TOLEDO - LUCAS COUNTY PLAN COMMISSIONS

REF: PUD-10003-23
DATE: January 12, 2024

SUBJECT: Planned Unit Development for Multiple Commercial Buildings on a Lot at 0 Glendale Avenue

SITE PLAN

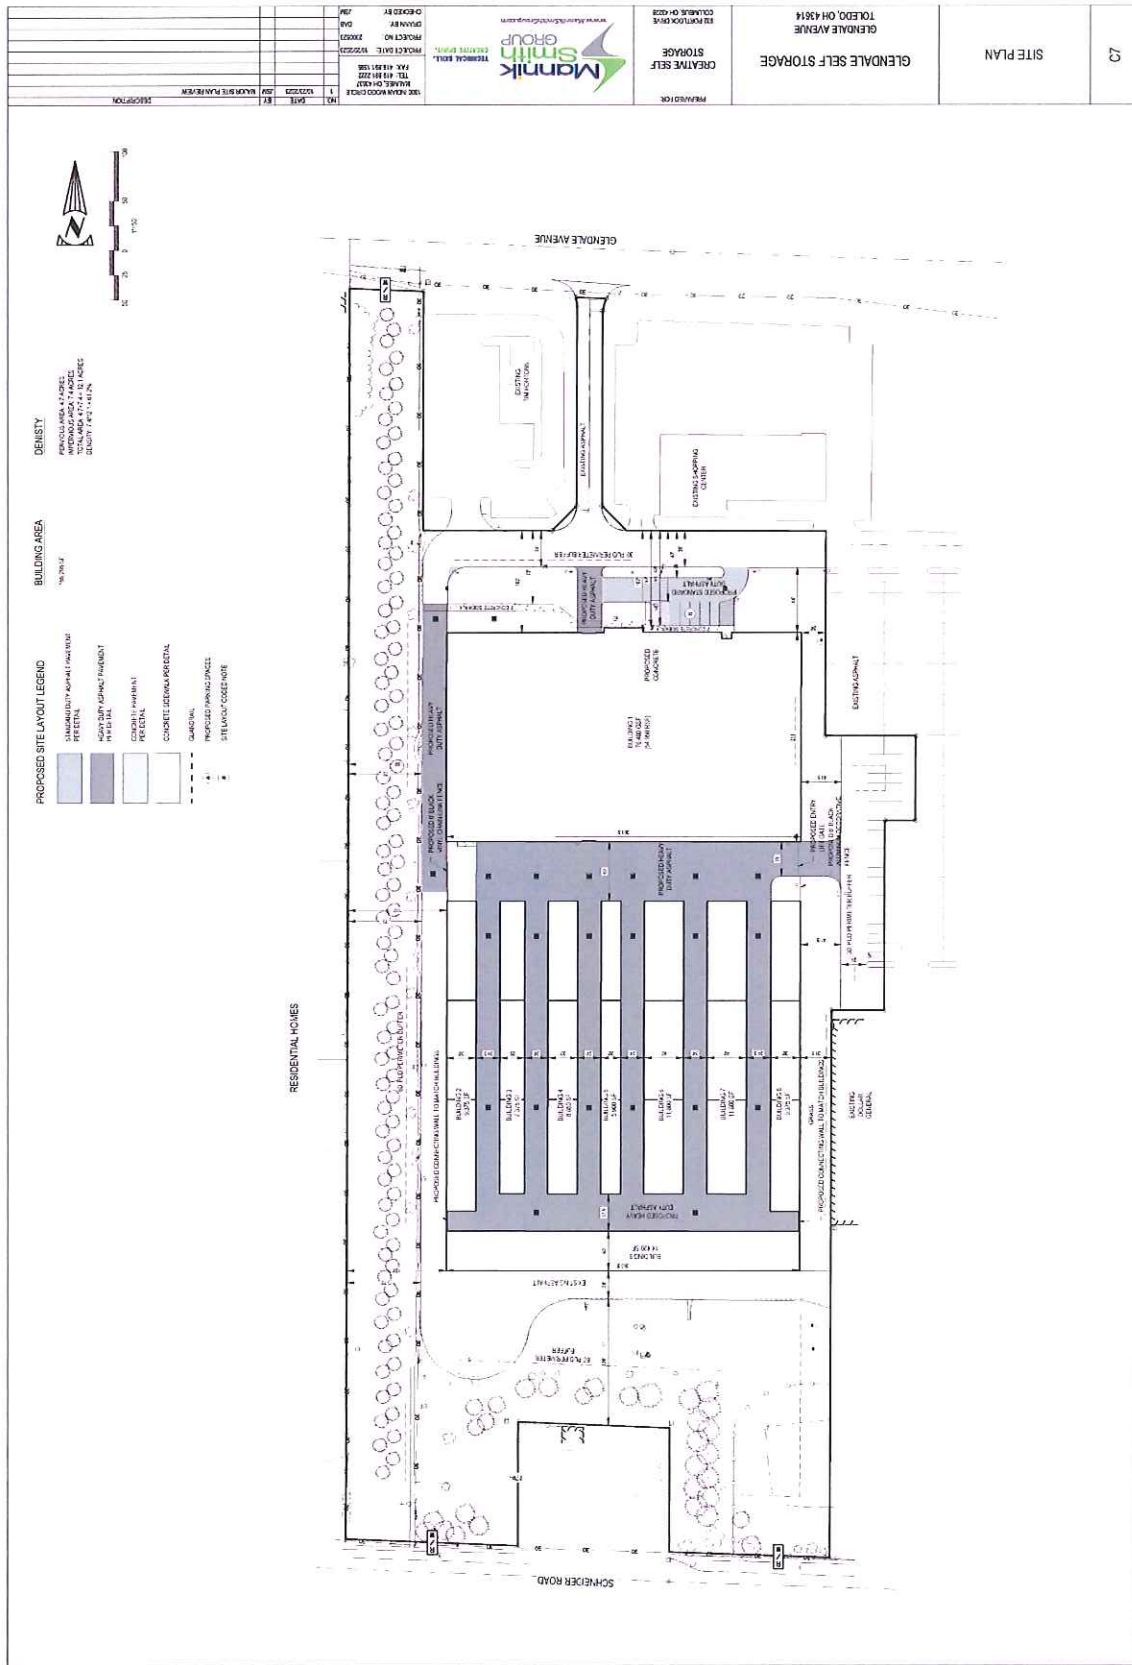
35. The material for both the proposed 6-foot black vinyl chain-link fence and the 6-foot black aluminum decorative fence and entry gate shall be the same. The fences and entry gate shall be decorative black aluminum and shown as such on a revised site plan and landscape plan.

36. Per TMC§1107.0304, the Off-Street Parking Schedule requires one bicycle parking slot per 10 parking slots. No bicycling parking is proposed. A minimum of two bicycling slots shall be shown on a revised site plan.

37. Per TMC§1103.1010(D) PUD developments are required to provide sidewalks, built to city specifications along both sides of all streets, public or private. Sidewalks or other approved pedestrian walkways must be provided to link nonresidential areas with residential areas, both inside and outside the PUD. To provide a complete connection, a sidewalk shall be provided from the front entry of Building 1, east to the edge of the property, to connect to the existing shopping center. The sidewalk shall be shown on a revised site plan.

- a. Per TMC§1103.1008(B) commercial PUD developments shall maintain a minimum open space depth of 30 feet on all perimeter property lines and a minimum open space depth of 60 feet when abutting a Residential District. **The perimeter depth along the south and west is acceptable as depicted. The perimeter depth along the east is not acceptable as depicted, unless additional property is obtained as indicated by the Engineer. The applicant shall continue to work to secure additional area or adjust the site plan to comply. The perimeter depth along the north is not acceptable as depicted. The Applicant shall obtain a waiver for the required open space depth where it does not comply along the north.**

LANDSCAPE PLAN

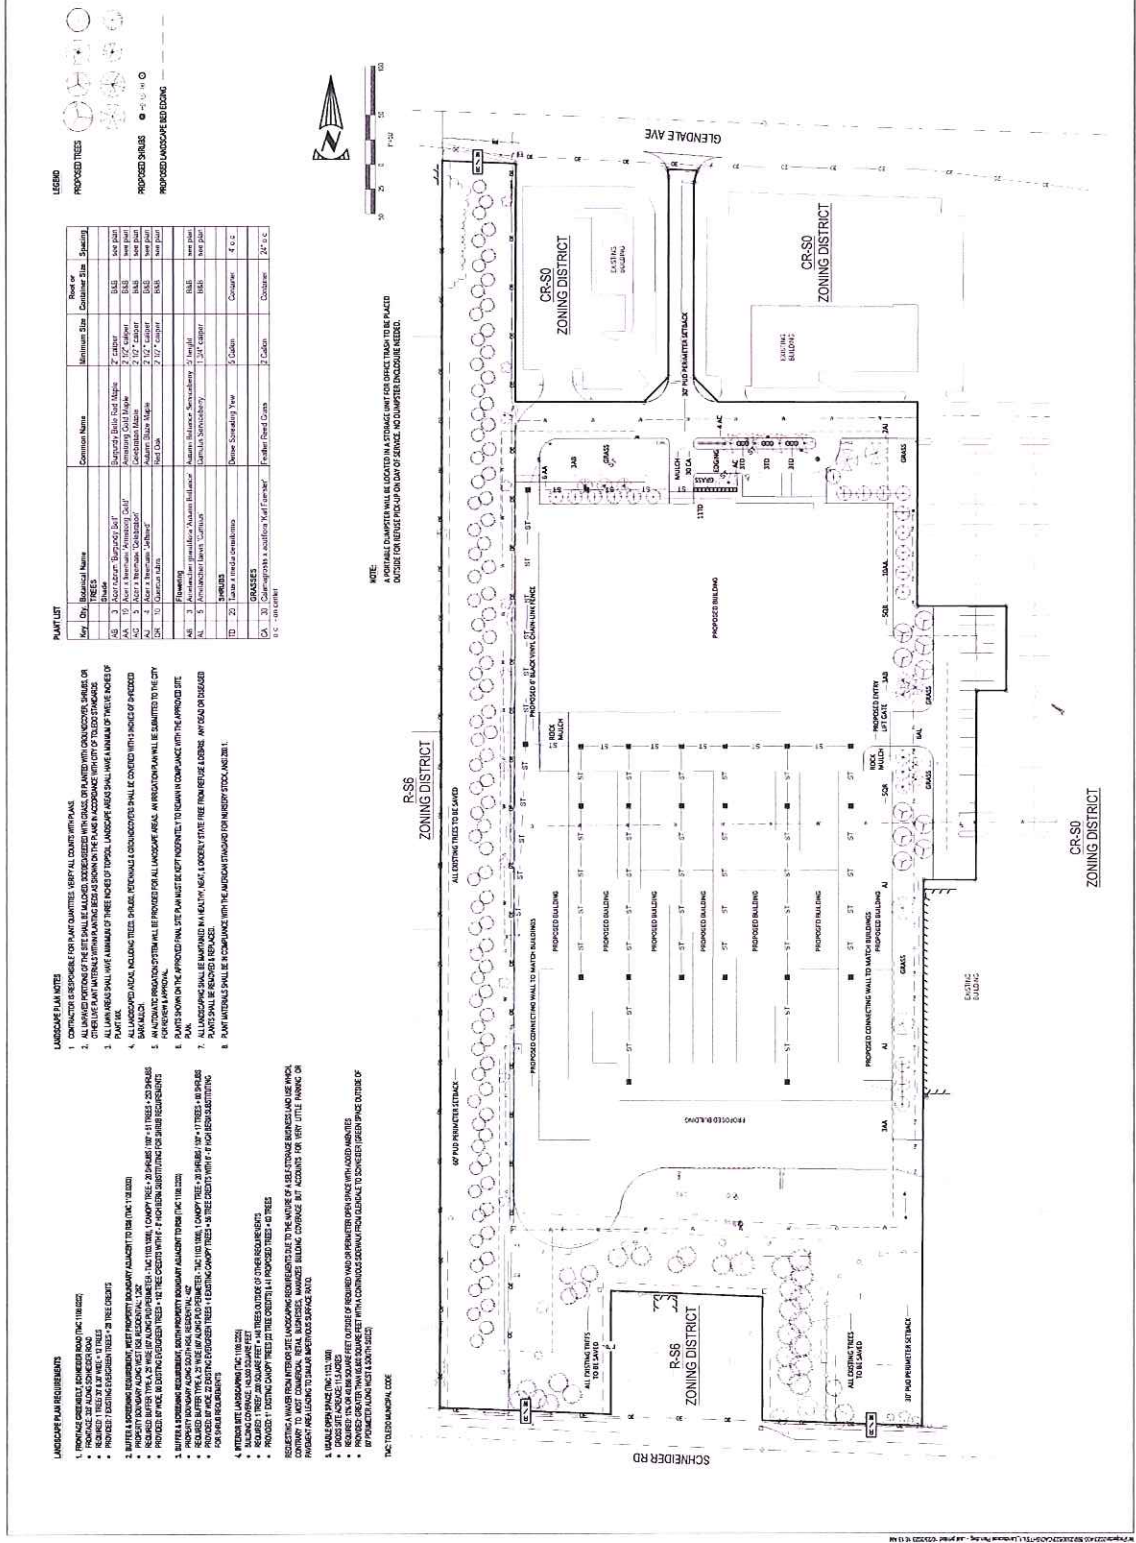
- c. Per TMC§1108.0205(B), in addition to the other landscape requirements for buffer areas, frontage greenbelts, and landscaping for parking lot areas, the following shall be provided: one 2-inch caliper tree for every 1,000 square feet of building coverage (footprint); foundation plantings along all portions of the building that are visible from the public rights-of-way; and landscaping at all major building entrances. **Foundation plantings and entrance landscaping acceptable as depicted. Interior tree requirement not acceptable as depicted. One interior tree shall be provided in the area between Building 1 and Building 2 where “rock mulch” is**

noted. In addition, the Applicant shall obtain a waiver of the other required 155 interior trees.

- d. Per TMC§1108.0204(B.6), landscaped areas may not contain bare soil, aggregated stone, or decorative rock. Any ground area must be covered with hardwood mulch, grass, or other vegetative ground coverage. The proposed rock mulch is not permitted. **All areas that are noted as “rock mulch”, shall be hardwood mulch.**

Approve waiver to not provide the required interior trees except for one tree to be placed in the area on the submitted landscape plan, between Building 1 and Building 2, where “rock mulch” is noted. Approval of the waiver is due to the fact that the nature of a self-storage facility is to provide storage area that translates to building area for which this standard is based.

BUILDING ELEVATIONS

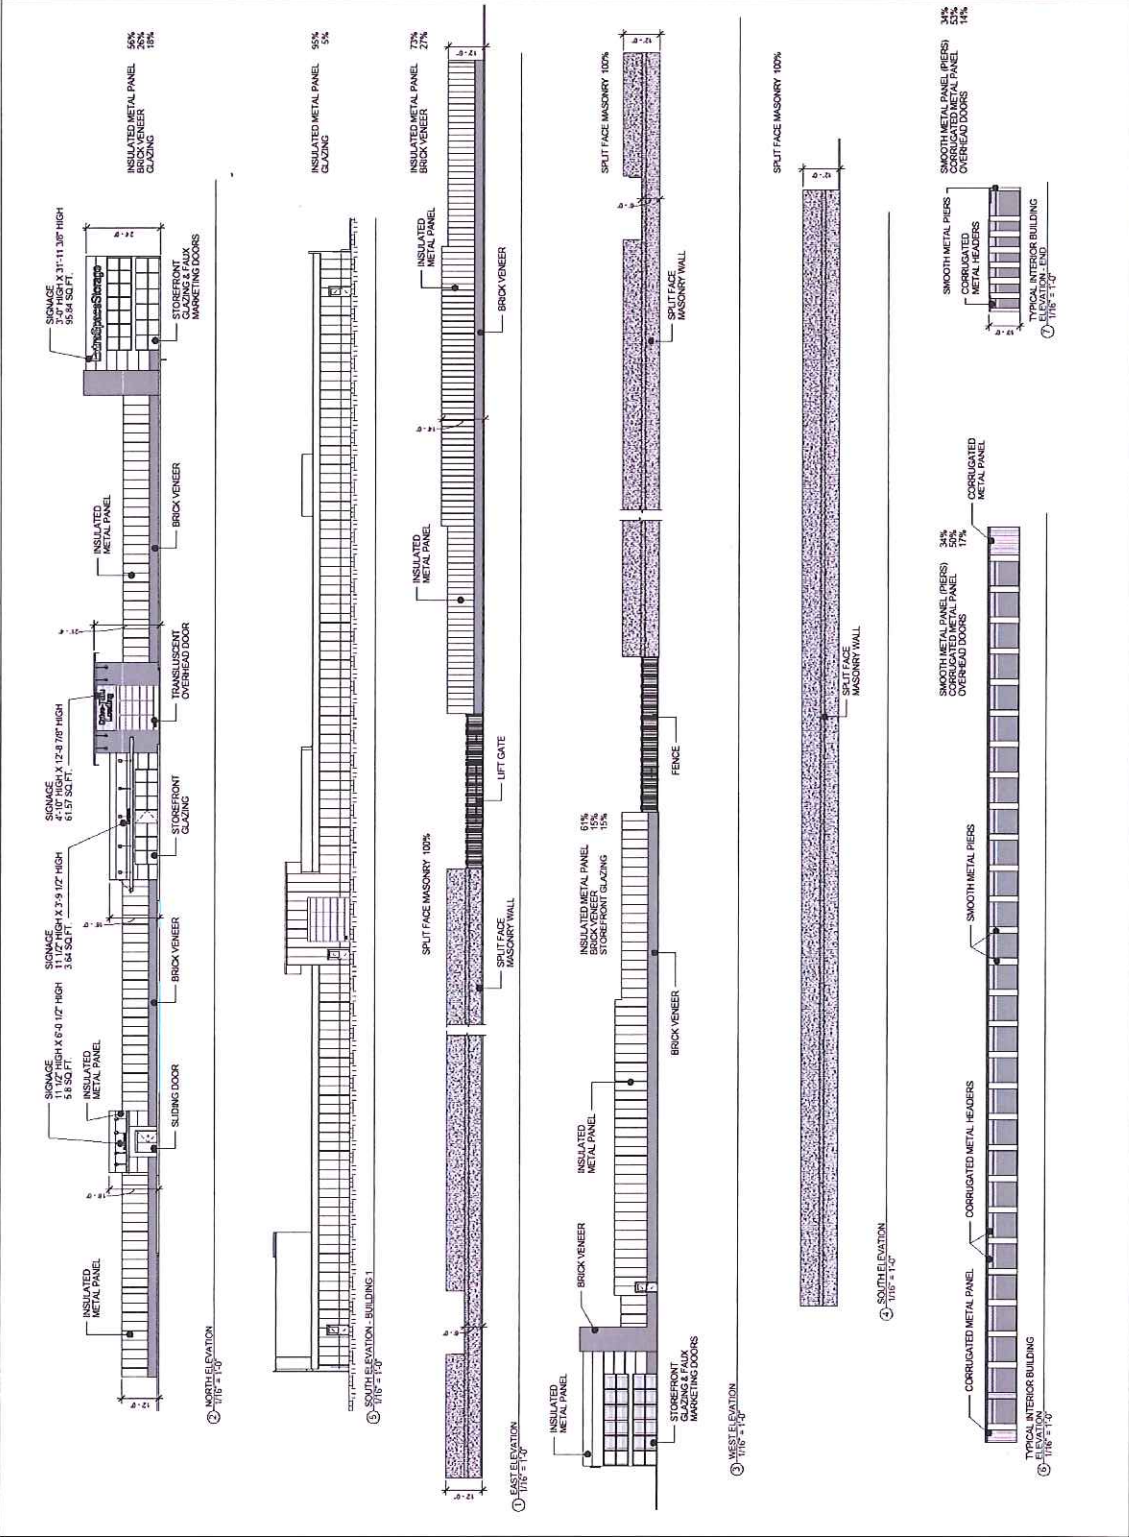
- a. Building 1 - The north elevation depicts 56% Insulated Metal Panel, 26% Brick Veneer, and 18% Glazing. The south elevation depicts 95% Insulated Metal Panel and 5% glazing. The west elevation depicts 61% Insulated Panel, 15% Brick Veneer, and 15% Storefront Glazing. The east elevation depicts 73% Insulated Metal Panel and 27% Brick Veneer. The predominant material for all of these elevations is Insulated Metal Panel. **Acceptable as depicted, provided the provided the face sheet of the insulated metal panel is the 22 gauge option.**

- b. Building 2 – The west elevation depicts 100% Split Face Masonry. A detail for the north and south elevations were not provided. These elevations should also be split face masonry. The east elevation will consist mainly or overhead doors separated by

- d. Building 8 - The east elevation depicts 100% Split Face Masonry. A detail for the north and south elevations were not provided. The west elevation will consist mainly of overhead doors separated by smooth metal piers, with corrugated metal headers along the top of the building façade, and corrugated metal panels framing the ends of the building facade. Split face masonry is not allowed as a predominant building material. **Since this building is visible from a right-of-way, with the exception of the south and west elevations, it shall be constructed of brick or other permitted building material as approved by the Plan Director. A typical detail for the north and south elevations for this building shall be submitted.**

- e. Building 9 - The south, west and east elevations depict 100% Split Face Masonry. The north elevation will consist mainly of overhead doors separated by smooth metal piers, with corrugated metal headers along the top of the building façade, and corrugated metal panels framing the ends of the building facade. Split face masonry is not allowed as a predominant building material. While this building faces a right-of-way on the south, it is not visible with the existing landscape buffer in place. Therefore, staff supports a waiver from the material requirement. **The Applicant shall obtain a waiver for building material on the south elevation.** The east elevation of Building 9 is connected via a 6-foot-high wall to Building 8. **The 6-foot-high wall as well as the east elevation of Building 9 shall be constructed of brick or other permitted building material as approved by the Plan Director to match the east elevation of Building 8.**

- f. The elevations do not indicate the color for the proposed materials. Revised elevation drawings will shall be submitted to reflect not only the material changes, but also color of all materials. All revisions must be in compliance with TMC§1109 – Design Standards.

Approve waiver for the predominant building material for Building 9 to be split face masonry. While this building faces a right-of-way it is not visible with the existing landscape buffer in place.
